## DUST COVER INTERFERENCE

Figure 1: Interference between A-spec dust cover and 22t CDX Sprocket

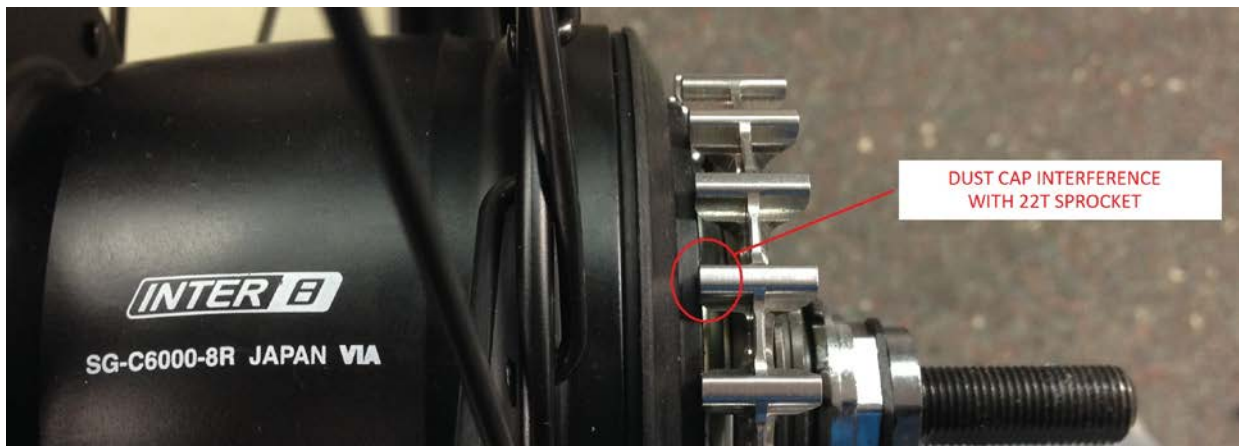
- MY 2016 Shimano Nexus 8 hubs use a new dust cover that will interfere with the Gates 22t CDX sprocket.
- Shimano offers a B-spec dust cover that is narrower, and will not interfere with the 22t sprocket.
- The 24t CDX sprocket will not interfere with either A-spec or B-spec dust covers.
